DEPARTMENT OF THE ARMY
OFFICE OF THE ASSISTANT CHIEF OF STAFF FOR INSTALLATION MANAGEMENT
600 ARMY PENTAGON
WASHINGTON, DC 20310-0600

RE: Final Groundwater Supplemental RCRA Facility Investigation Work Plan, Revision 4, Army's Response to Comments, New Mexico Environment Department Approval with Modifications letter dated April 18, 2018 reference number HWB-FWDA-15-001, Fort Wingate Depot Activity McKinley County, New Mexico.

Figure 9-1
 PROPOSED REPLACEMENT
 ALLUVIAL WELL MW34
 GROUNDWATER SUPPLEMENTAL
 RFI WORK PLAN
 FORT WINGATE DEPOT ACTIVITY
 MCKINLEY COUNTY, NEW MEXICO

Monitoring Well MW-23

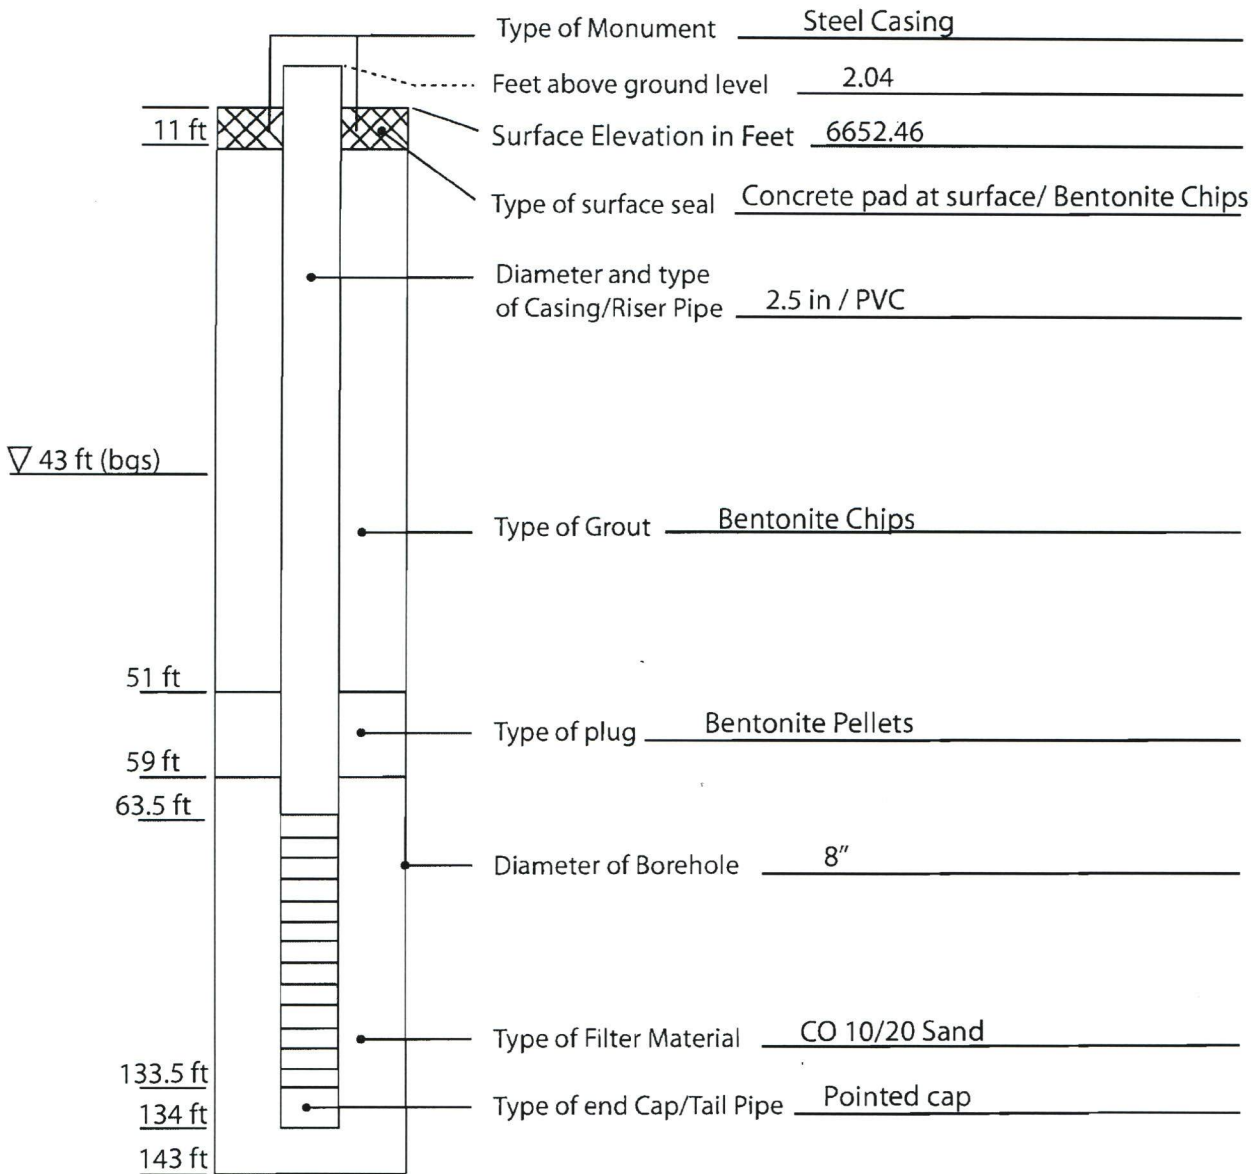
NMED Comment: Some organic contaminants related to site activities have been detected in samples obtained from well MW23 sporadically while no organic contaminants have been detected from well MW24 in recent years. Well MW23 is screened from 64 to 134 feet below ground surface (bgs) while well MW24 is screened from 16 to 66 feet bgs according to Appendix B in the 2011 and 2012 Monitoring Well Installation and Abandonment Report Version 1, dated December 2012. The groundwater quality monitored in wells MW23 and MW24 has not been consistent

according to Table 5-1 in Groundwater Periodic Monitoring Reports. The saturated zones were reportedly encountered at 43 and 17.6 feet bgs in wells MW23 and MW24, respectively. Two different aquifers may be present in the vicinity of the proposed well BGMW11. An abandoned well (Wingate91) was installed in a similar location to where well BGMW11 is proposed according to Figure 5 in the Interim Facility- Wide Groundwater Monitoring Plan Version 2, dated March 28, 2008. Well Wingate91 was installed to a depth of 113.12 feet bgs in 1963; however, the well was not likely to be screened as a monitoring well because it was installed as a water supply well. Accordingly, construction data for well Wingate91 will not likely provide data on the presence or absence of separate aquifers. Propose to investigate whether separate aquifers are present in the response letter. If both shallow and deep aquifers are distinctly present in the vicinity of proposed well BGMW11, two separate background monitoring wells must be installed.

Army Response: Sporadic detections of organics have been recorded at well MW23 since the initial sampling conducted when the well was installed in 2011. MW24 has not had any detections of organics. The proposed location of BGMW11 is upgradient of MW24.

The intent of the background wells, such as BGMW11, is to assess the natural quality of ground water with similar origins and from depths comparable to the water sampled within the alluvial groundwater monitoring wells. The alluvial groundwater monitoring wells within the northern plume are screened at depths comparable to MW24, not the deeper MW23. For the intended purpose as a background well, a single shallow well is appropriate.

The water quality values reported in MW23 and MW24 are consistent with other alluvial monitoring wells found at FWDA, and are within range of groundwater found from a single water-bearing unit. Reviewing water quality data from MW23 and MW24 since 2012 to current shows the values have been within a ten-percent range of each other. Variances observed in the measurements between the two wells is expected, as change in ambient temperature and instrument accuracy in the field affects readings. Though MW23 and MW24 are screened at different depths, the boring log from MW23 (attached) does not support the existence of two separate and distinct water-bearing zones. The alluvium found at the FWDA is a highly heterogeneous unconsolidated silt with sand and clay, and varies between sandy to clayey intervals that are difficult to correlate between boreholes.

MW23 has much different purpose as a sentinel well for a nearby private production well and has a well screen length and depth that is intentionally similar to that private well. The sporadic, low-level detections in this well will be considered in the on-going efforts to define the northern groundwater plume.

The Army does not believe a separate investigation is needed proposes to forgo the investigation of multiple water bearing units within alluvium at the proposed BGMW11 location. The Army also proposes to install BGMW11 as stated in the above referenced work plan, with a targeted depth consistent with MW24, to achieve non-impacted native groundwater for the evaluation of groundwater background values.
